Subject: Peer Review - Noise Impact Assessment (NIA) - Olds Data Center
Englobe reference: 02602899.000

Noise Impact Assessment Stage-1

Synapse Real Estate Corporation
Olds Data Center
W-04-033-01 W5M
2026-02-06

Figure 1A: Study Area Map

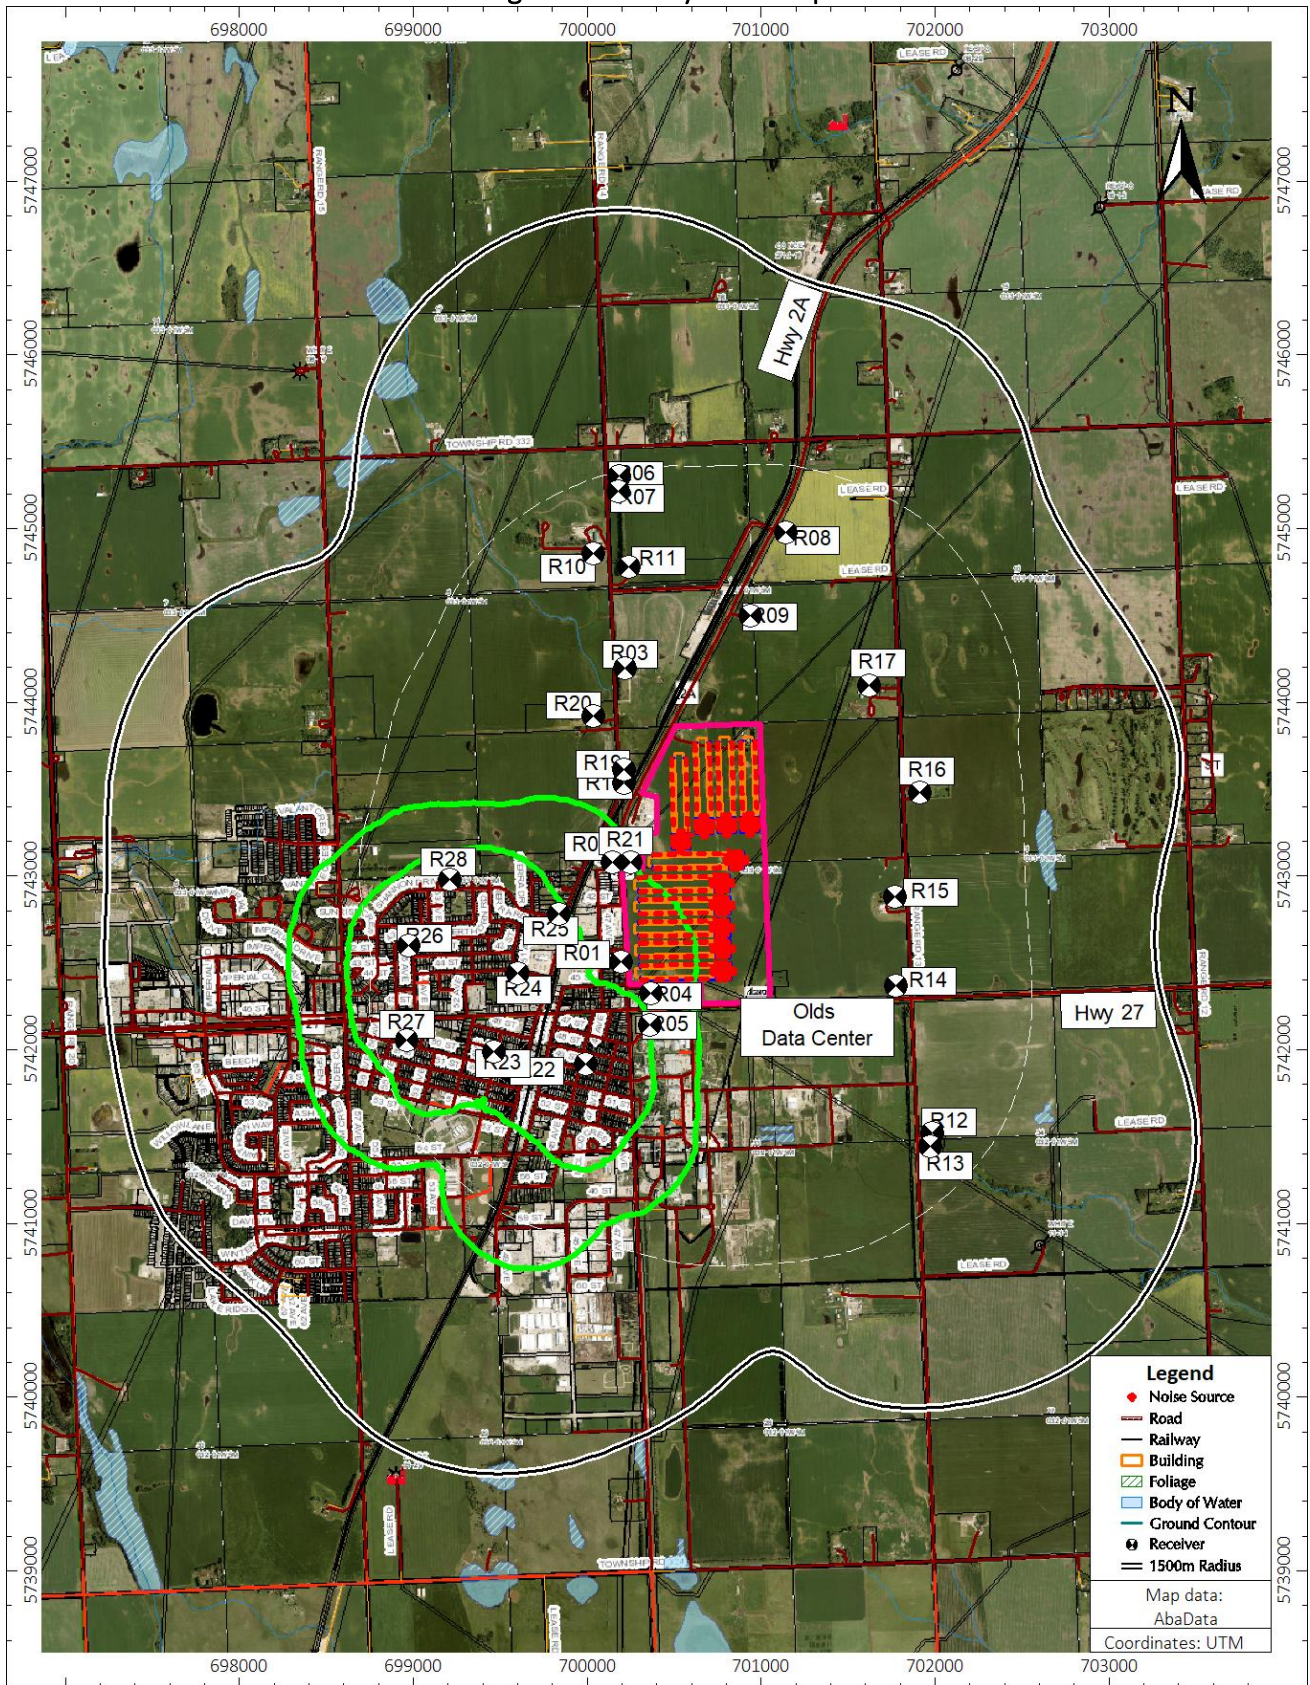
Comment #4 - In the NIA's "Study Area" Section, it is stated that "representative residences for the town are labeled as R22 to R28 at different receiver locations". However, based on Figure 1A, in many of these cases potential points of reception located closer to the proposed Data Center do exist, which are typically considered worst-case unless it can be demonstrated that a point of reception further from the noise source is exposed to greater noise levels due to other factors, such as greater receiver elevation, unobstructed line-of-sight to the noise sources, etc. Additionally, many disabled CadnaA "Receiver" objects are visible in Figure 3, leading Englobe to believe that every potential point of reception in the Town of Olds was considered, which could be how R22 to R28 were selected, although this is admittedly only speculative since the methodology is not discussed in the NIA. It is recommended that the NIA be revised to provide greater clarity regarding how the locations for R22 to R28 were selected.

Comment #5 - In the NIA's "Study Area" Section, Figure 1A's Legend should be updated to indicate that the 1500m radius is represented by the dotted white line, consistent with the description given in the text body.

Figure 1B:3D Modeling

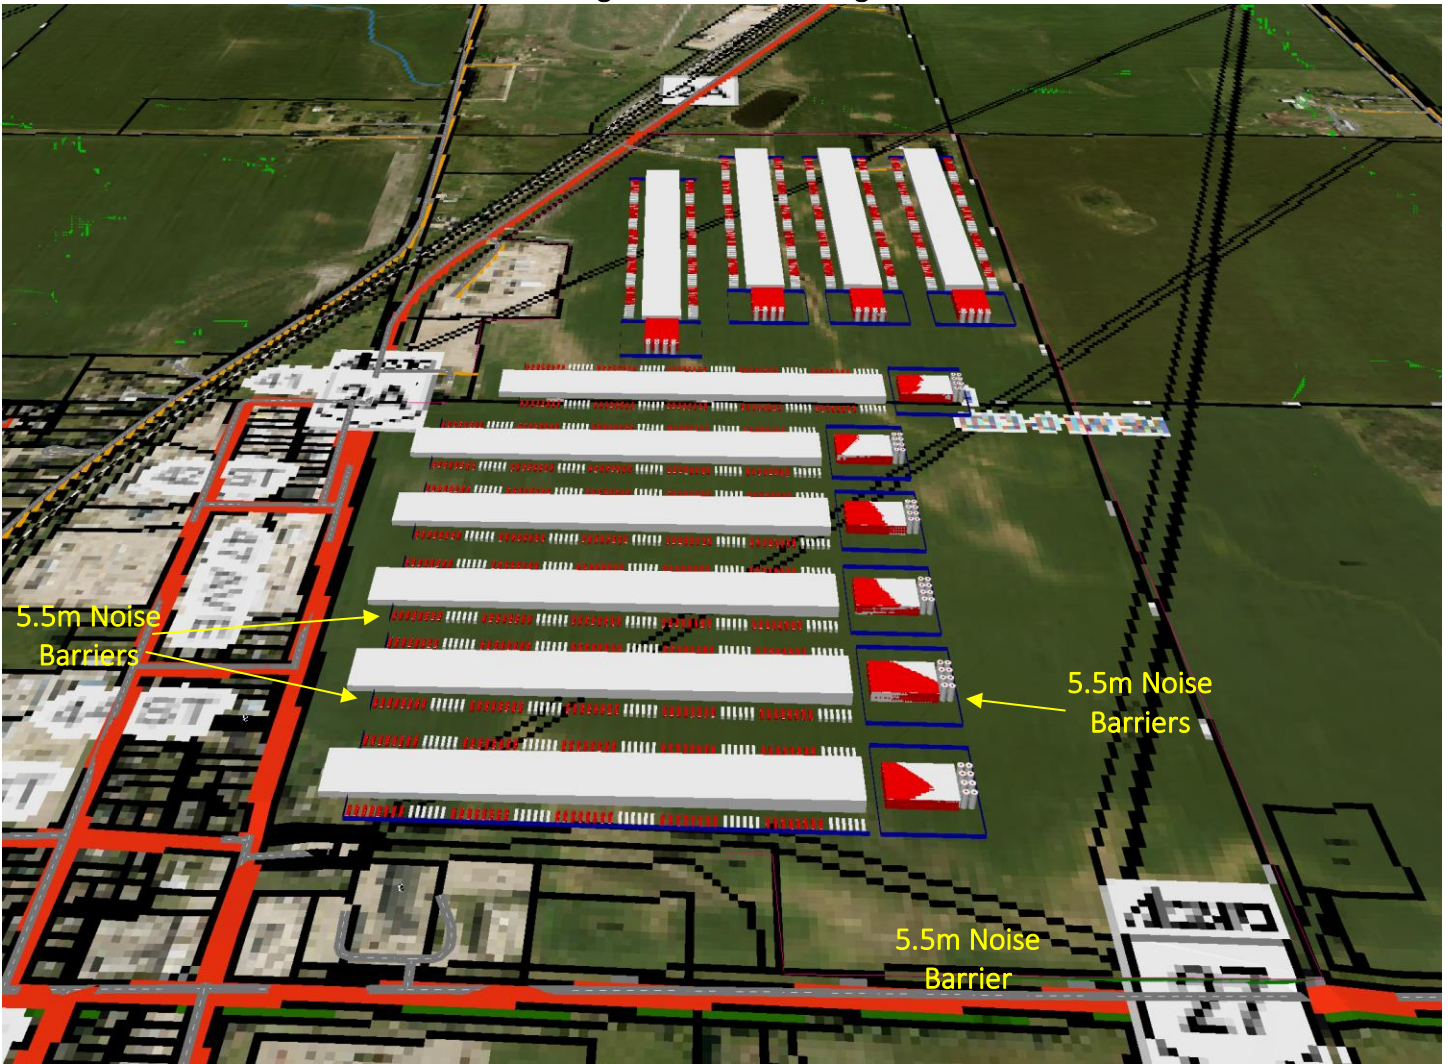
Comment #6 - In the NIA's "Study Area" Section, Figure 1B should be updated such that the "5.5m Noise Barrier" markup near the bottom of the figure points to the associated object in the figure, similar to the other markups.

Figure 2B: Noise Contour Map –Cumulative SPL -Nighttime

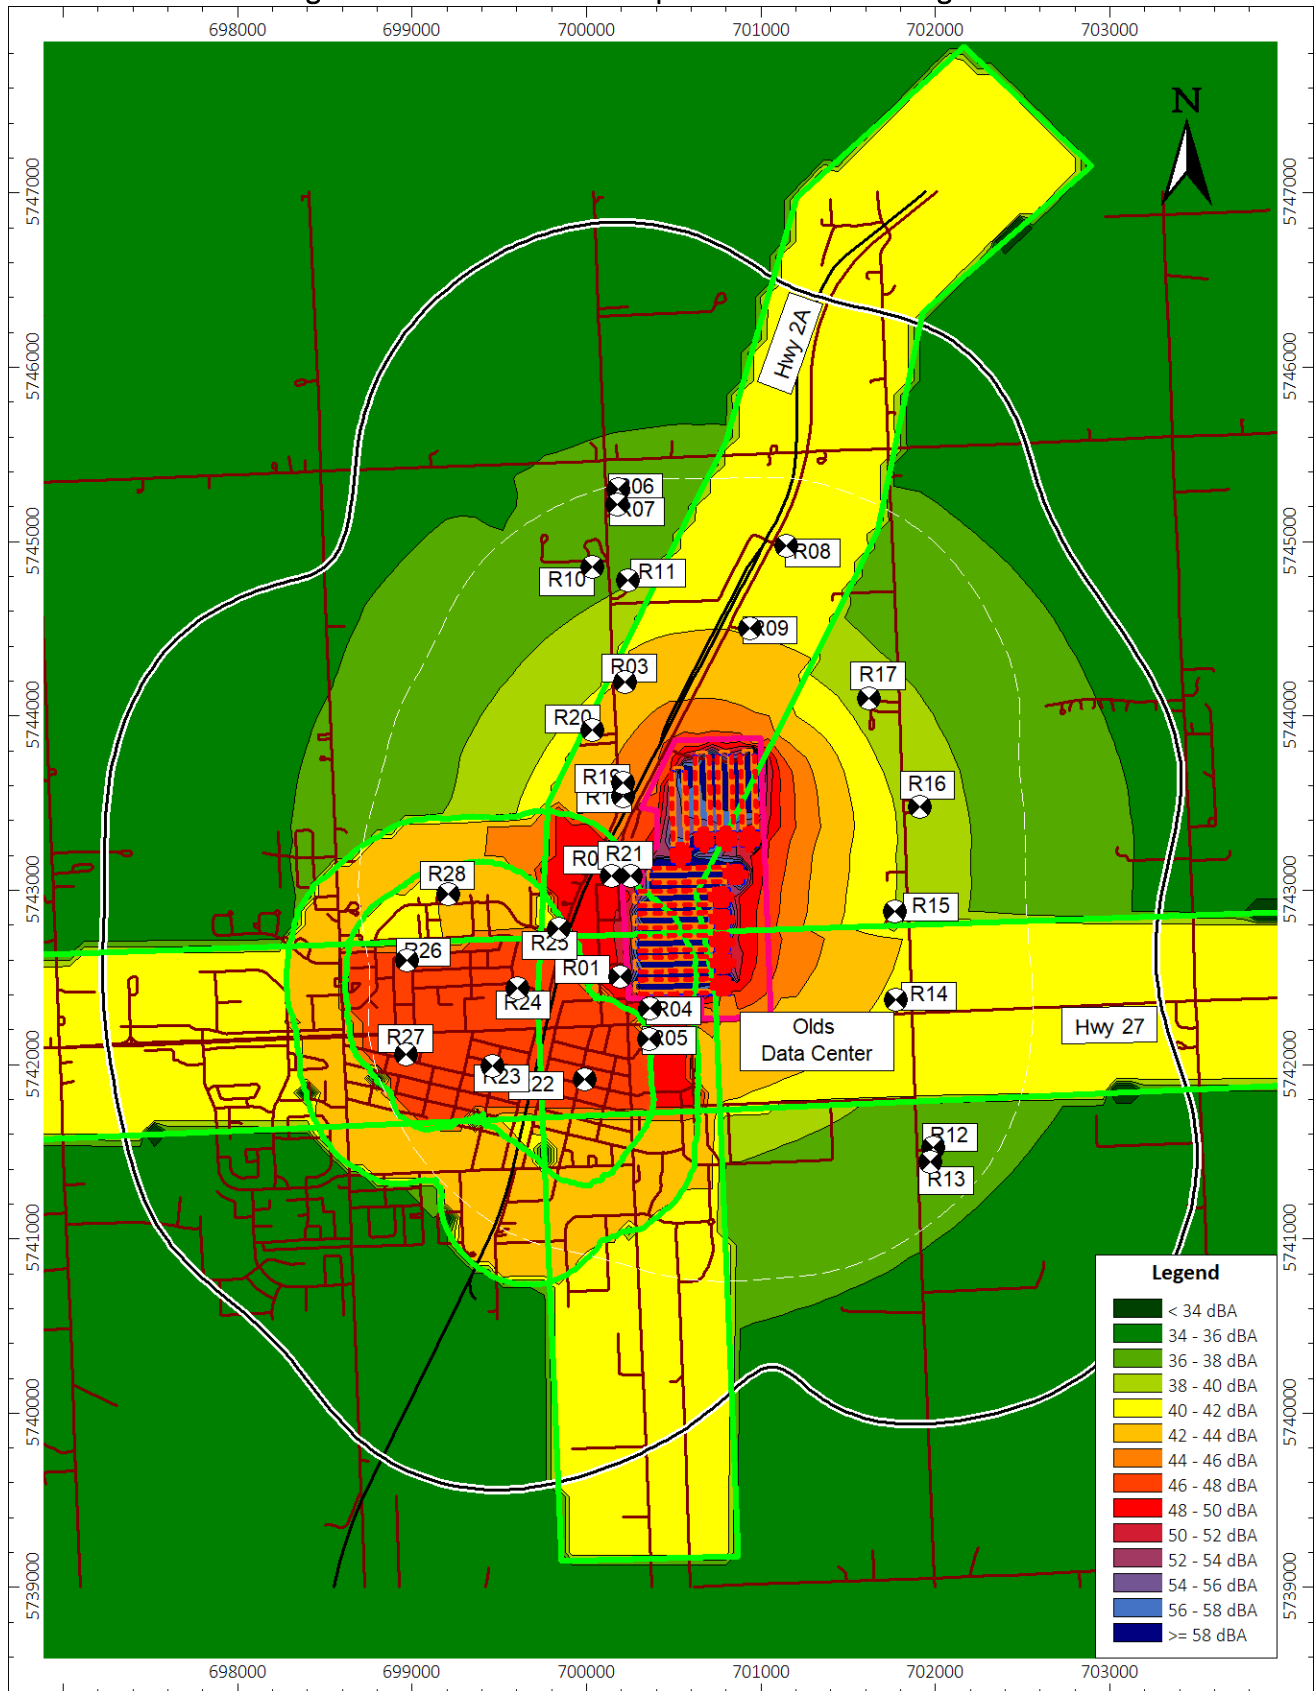
Comment #18 - In the NIA's "Results" Section, Figure 2B is labelled as the "Cumulative SPL Nighttime" results, but the values according to the Figure's coloured legend do not match the Cumulative SPL values given in Table 3. Also, it is unclear on Figure 2B what the green lines represent (in reference to the two circular shapes with green lines also visible on Figure 2A, as well as the green lines set approximately 500m on either side of Highways 2A and 27). It is recommended that the figures be updated for clarity.

Appendix C: Subject Facility Plot Plan

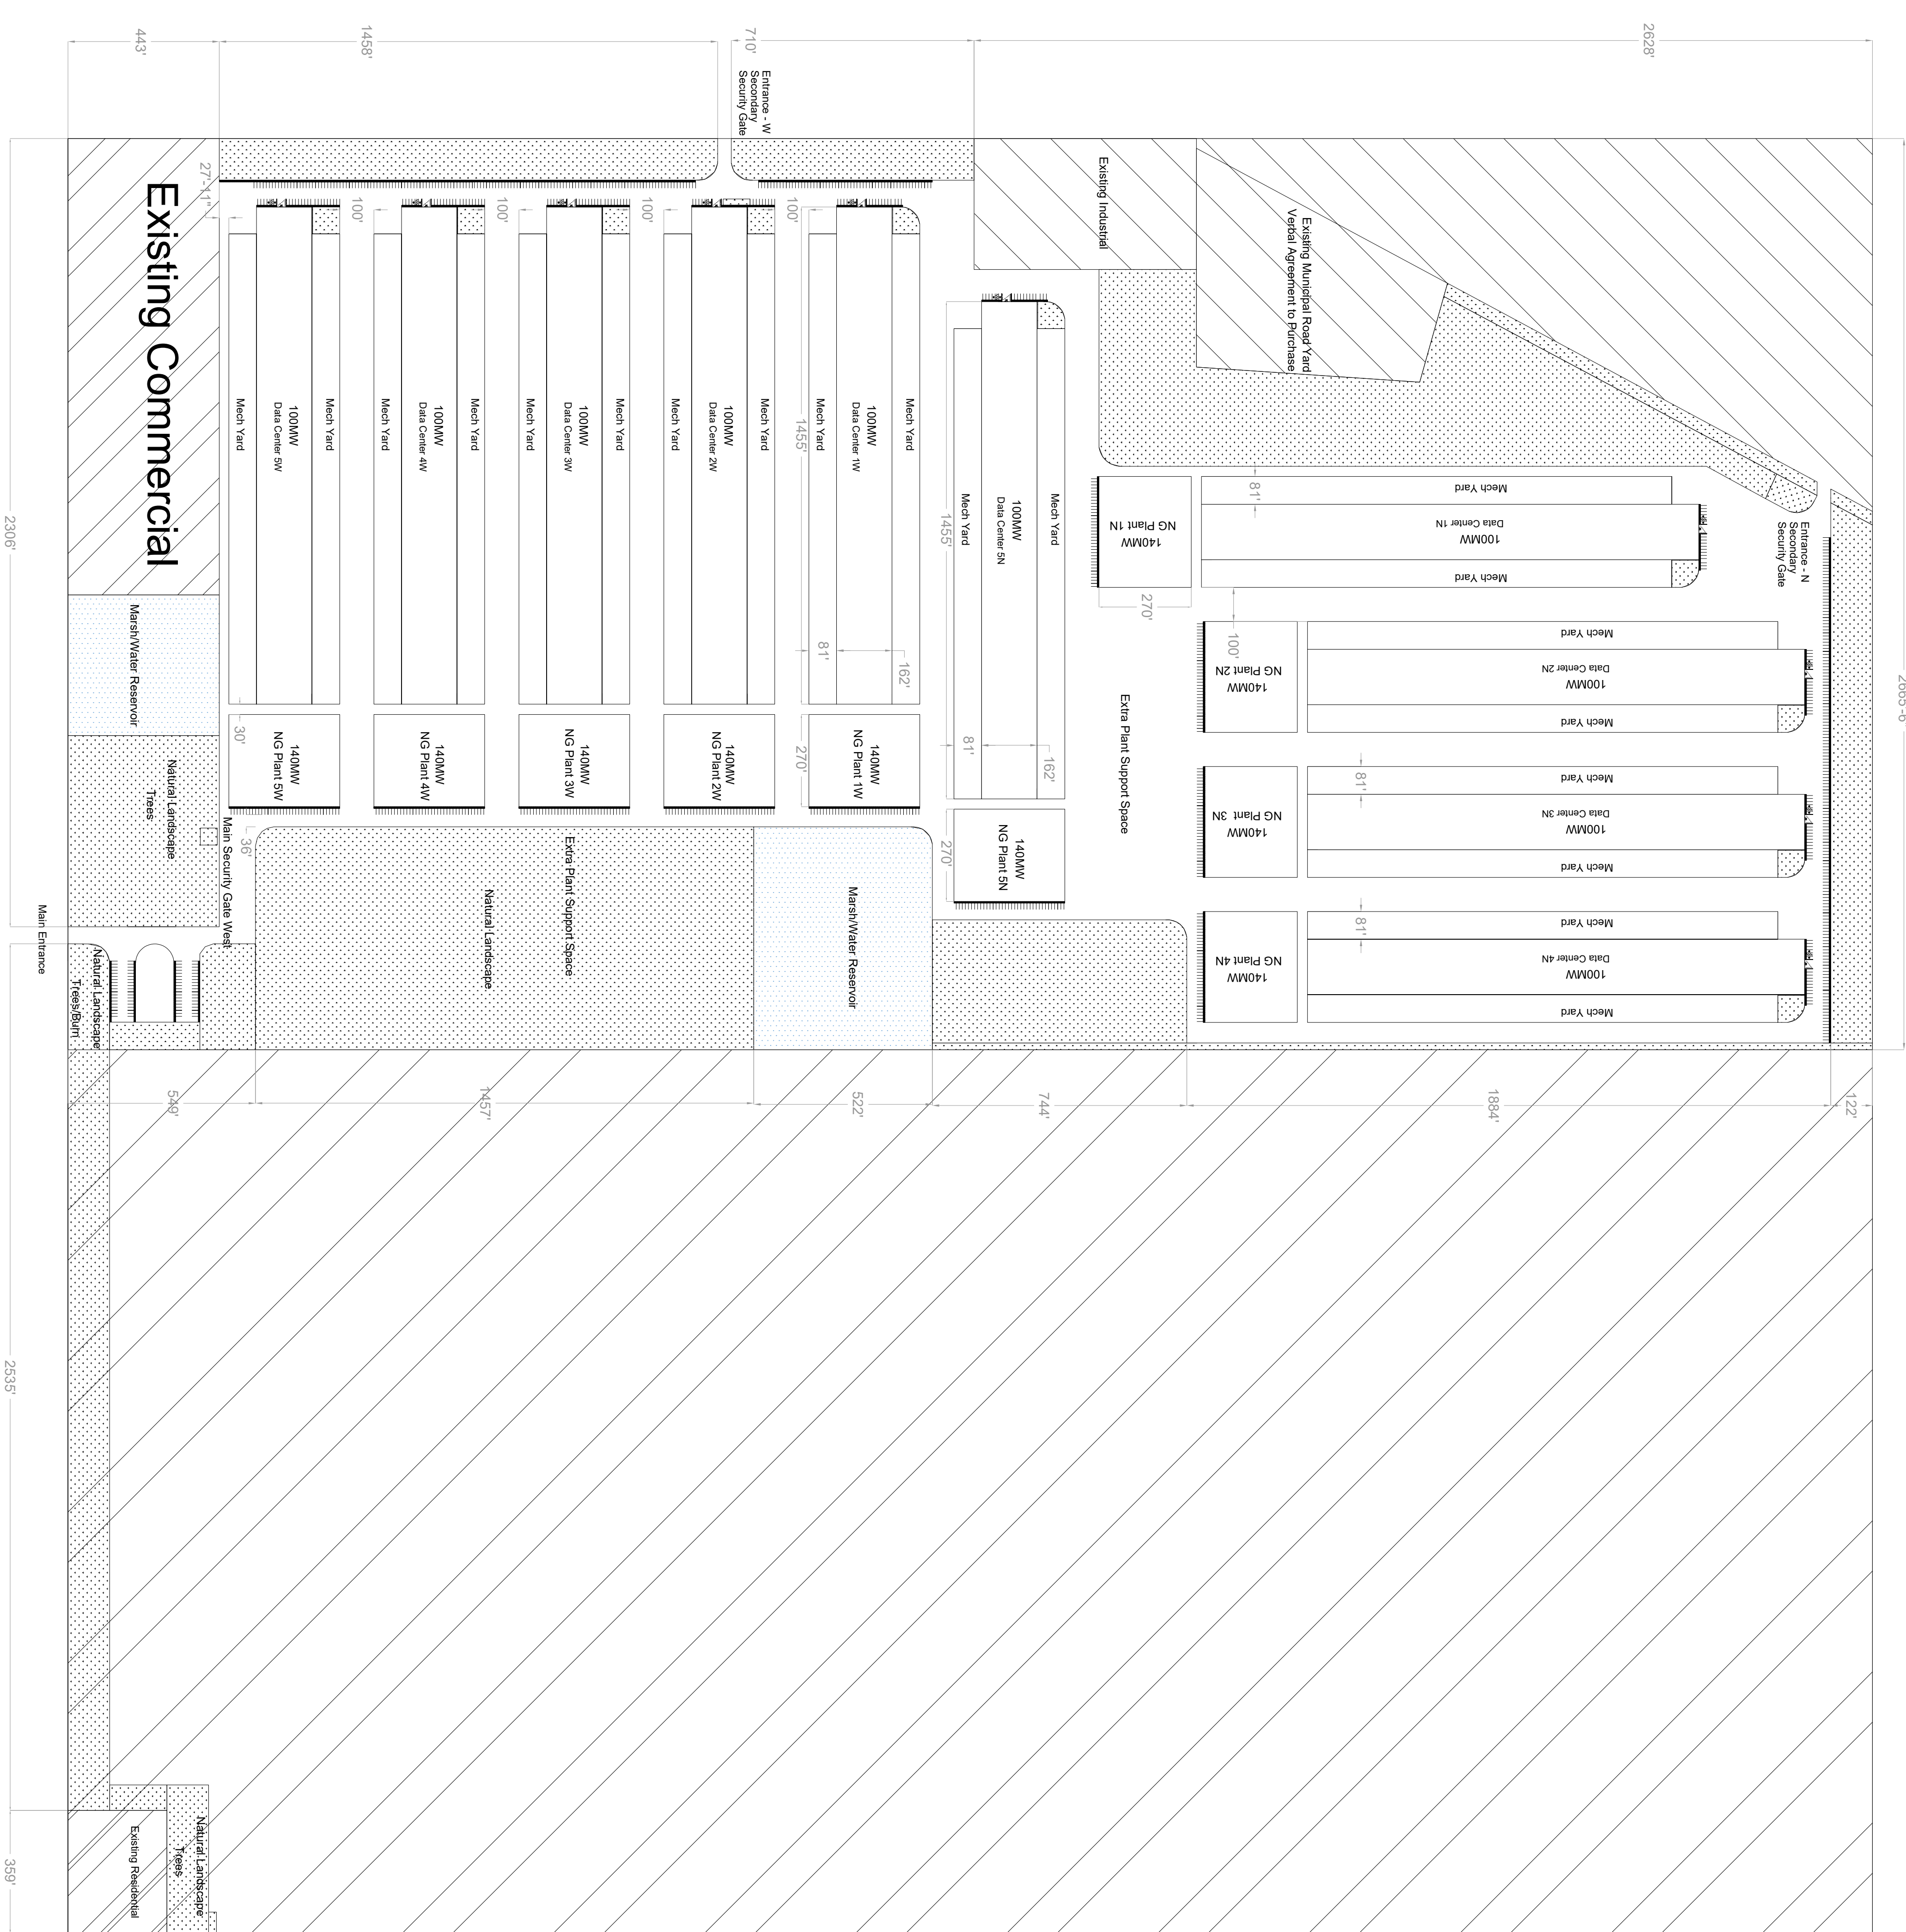
Comment #15 - In the NIA’s “Modeling Parameters” Section, regarding the “Topography” parameter, it is unclear whether or not the 15ft-tall berm located along the west side of the facility property (as shown on Drawing A101) has been included in the model. It is recommended that the NIA be updated accordingly.
